CITY OF KIRKLAND
Planning and Building Department
123 Fifth Avenue, Kirkland, WA 98033
425.587.3600 ~ www.kirklandwa.gov

MEMORANDUM

To: Design Review Board
From: Scott Guter, AICP, Senior Planner
Date: September 24, 2019
File No.: DRV19-00461
Subject: **112 LAKE ST S MIXED USE
DESIGN RESPONSE CONFERENCE**

Figure 1: Upper story setback departure diagram from page 42 of Attachment 2.

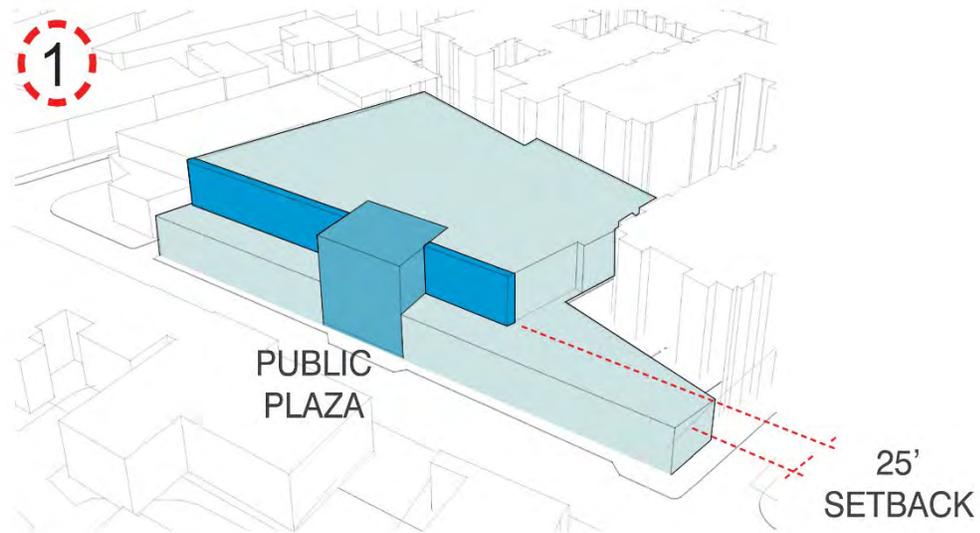
The applicant is requesting a reduction of the upper story setback requirement for Lake Street South (see page 42, Attachment 2). The upper story setback requirement is 30 feet from the property line to the exterior wall of the building. The measurements shall be taken from the property line abutting the street prior to any potential right-of-way dedication.

The applicant seems to be requesting to reduce the upper story setback by five (5) feet.

Upper Story Setback. Staff is unable to fully analyze the proposal for compliance with the upper story setback regulations. The diagram on page 42 looks to describe a reduction from 25 feet not 30 feet (see Figure 1). Staff recommends the applicant provide more detailed plans, i.e. site plan, elevations, and building sections, providing scaled measurement for staff to review.

The applicant should update the proposed plaza square footage calculation and site plan to depict the plaza area after right-of-way dedication. The applicant will be required to provide a public easement for public use of this portion of the plaza.

Figure 2: Proposed street level retail depth per page 18 of Attachment 2.

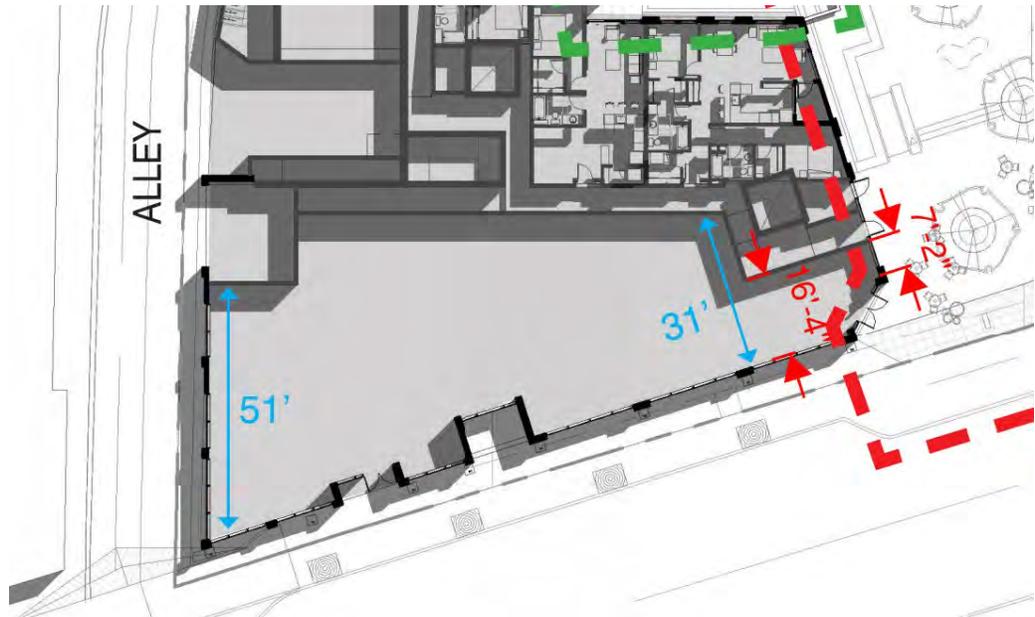
Staff Comment: This requirement is not required along Main Street South through Interpretation 17-3 issued by the Planning Director pursuant to KZC 170.40. The applicant provided the depth for street level retail on page 18 of Attachment 2. A portion of the proposed new retail space does not meet the minimum 20' depth requirement (see Figure 2). The final street level floor configuration will need to be reviewed by Planning Department and approved as part of the Design Response Conference decision. As proposed, the applicant would need approval of a minor reduction to the depth requirement from the DRB. At question is whether the proposal complies with the modification criteria described in the previous section.

Feedback from the DRB should be provided regarding this topic.

Figure 3: Calculation of average upper story setback from Main Street South (page 56 of the Conceptual Design Conference plan set).

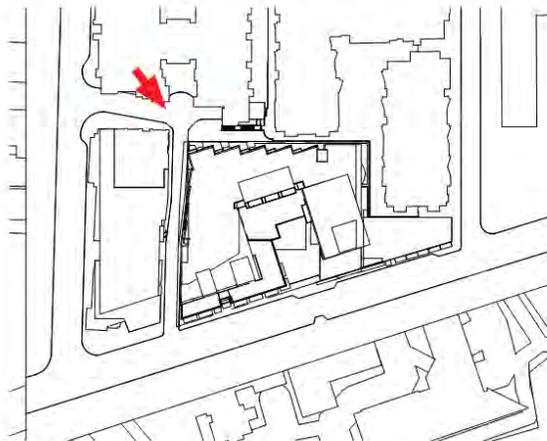
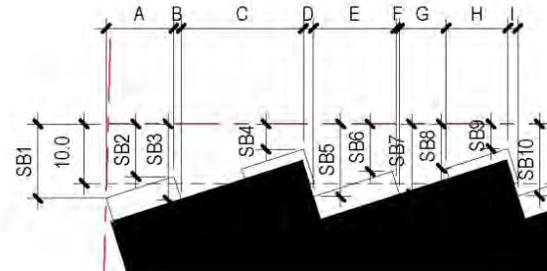
Main Street South: The applicant has provided a diagram but has yet to show compliance with the upper story setback from Main Street South. The applicant should clarify the average shown in Figure 3 by providing staff the distances illustrated in this diagram. The applicant should also provide staff with a "Total Upper Story Setback Area" calculation as required with KZC 50.10.5.e.

1. ECLECTIC RETAIL | SITE PLAN

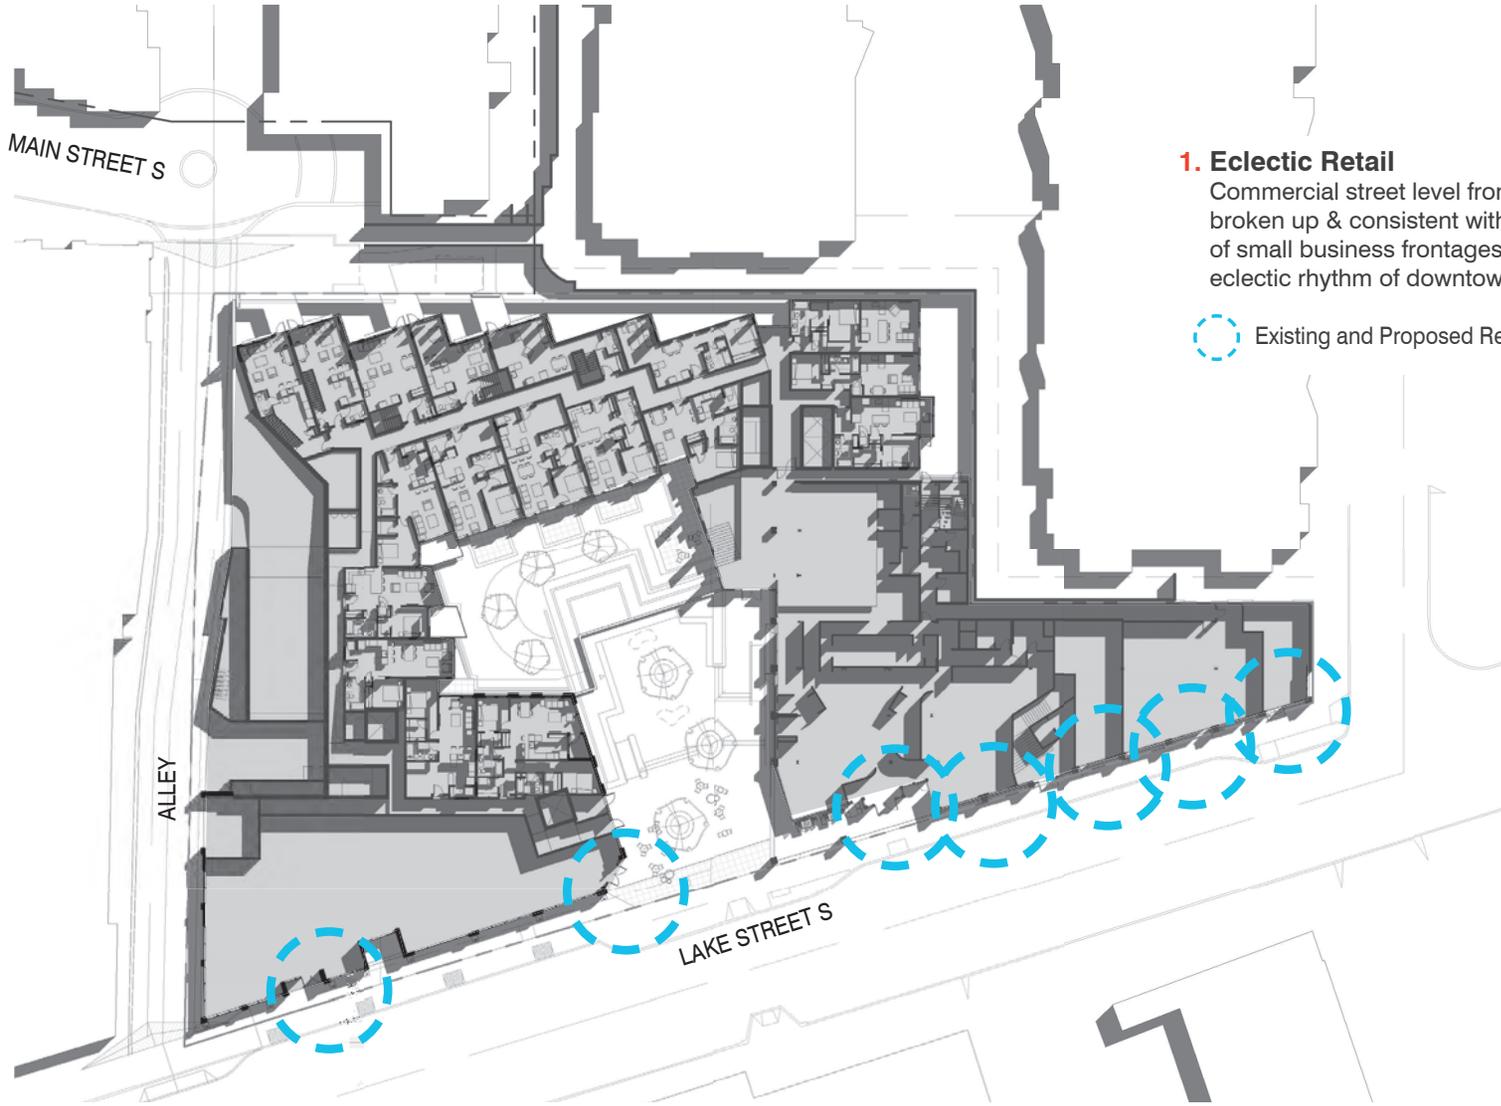
Commercial street level frontage to be broken up & consistent with the character of small business frontages and the eclectic rhythm of downtown.

2 & 3. PLAZA ACTIVATION & SUNKEN COURTYARD | SITE PLAN

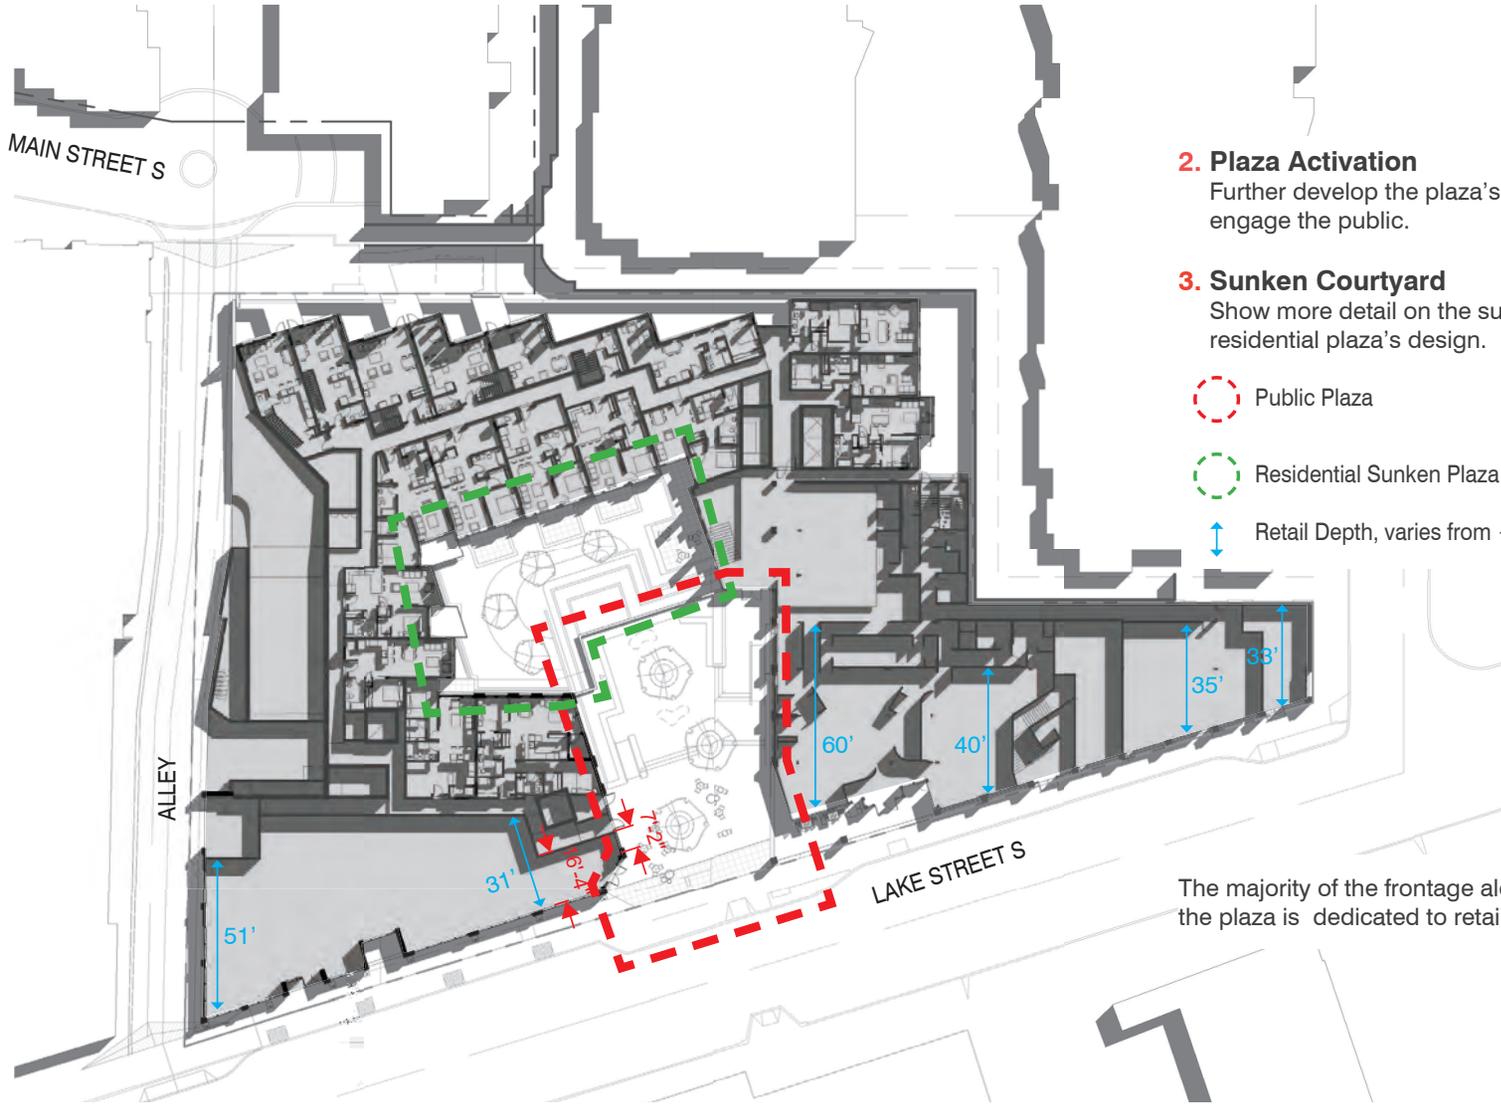
Further develop the plaza's program to engage the public.

Show more detail on the sunken residential plaza's design.

The majority of the frontage along the plaza is dedicated to retail.

4. UPPER FLOOR MODULATION | SITE PLAN

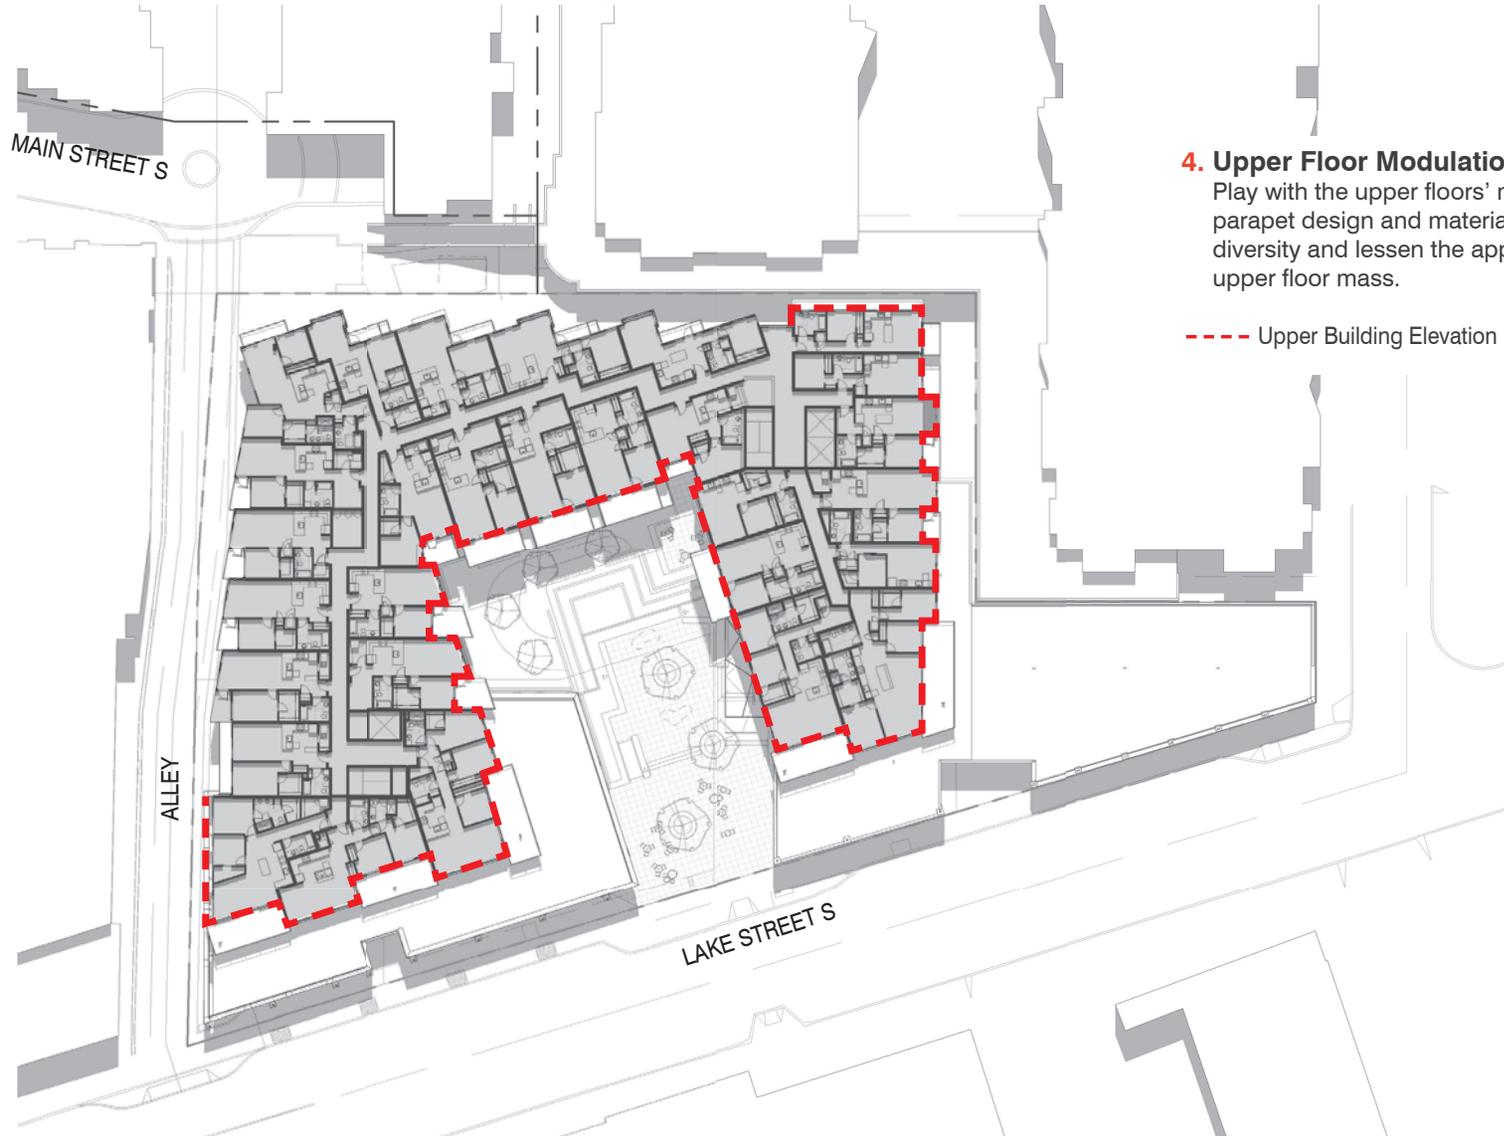
Play with the upper floors' modulation, parapet design and materials to add diversity and lessen the appearance of upper floor mass.

5. PEDESTRIAN-FRIENDLY MAIN | SITE PLAN

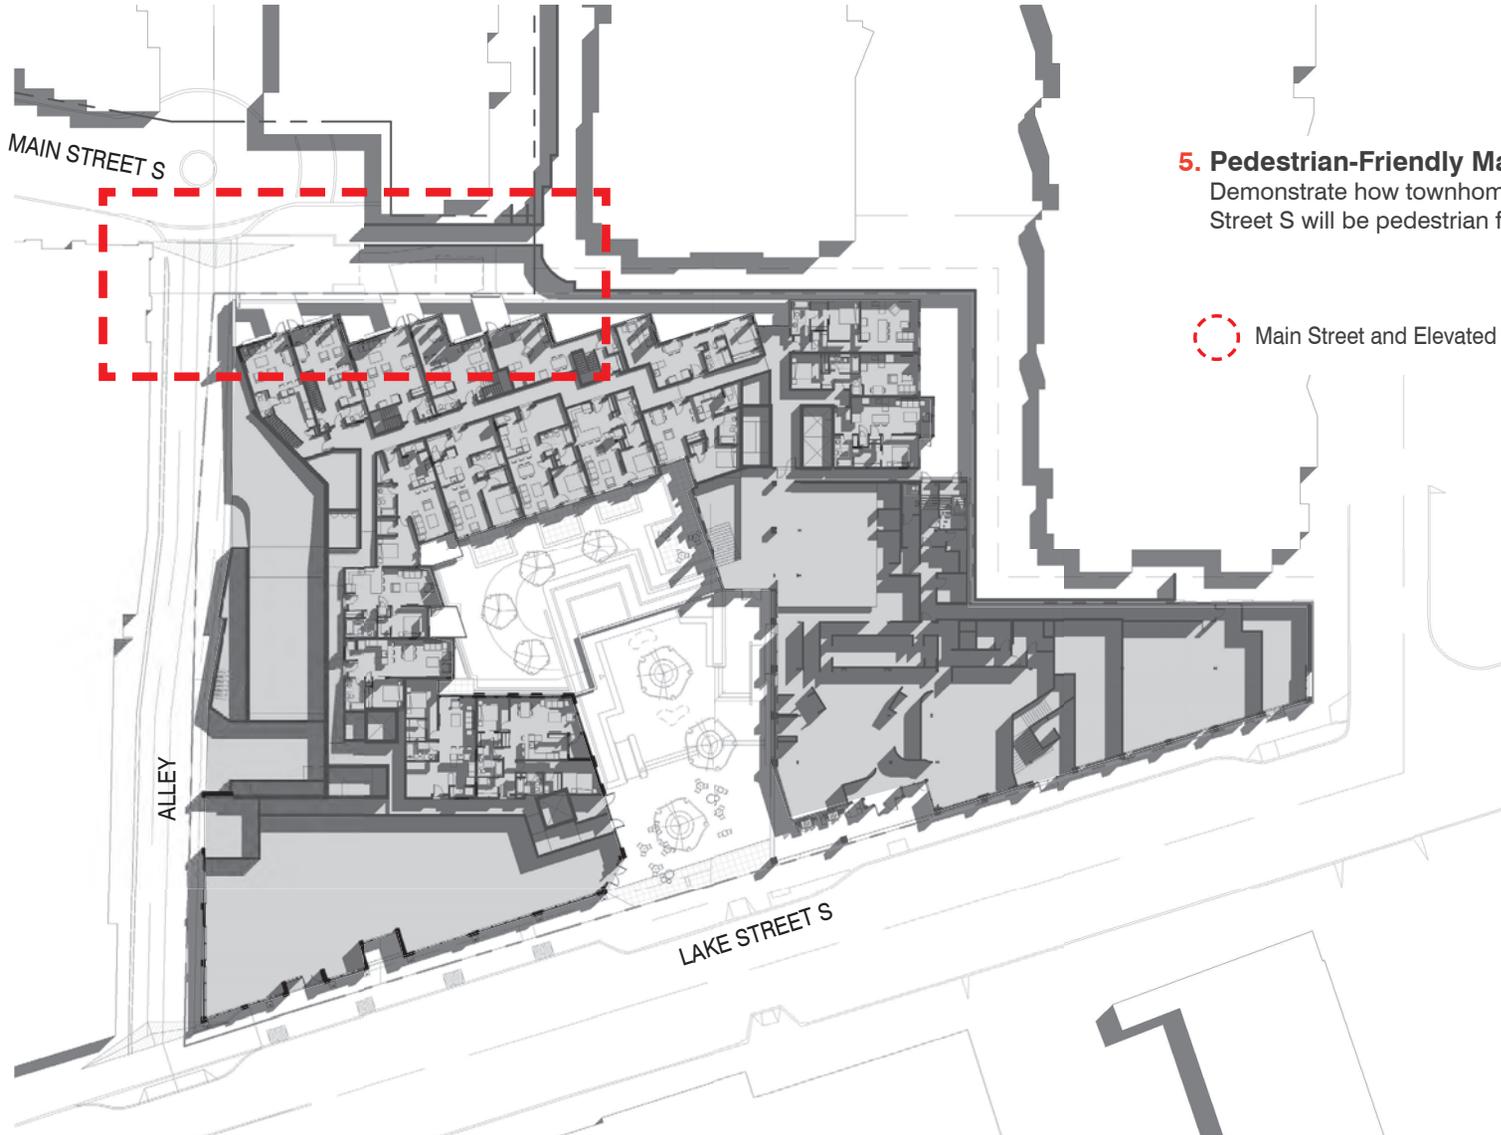
5. Pedestrian-Friendly Main St
Demonstrate how townhomes along Main Street S will be pedestrian friendly.
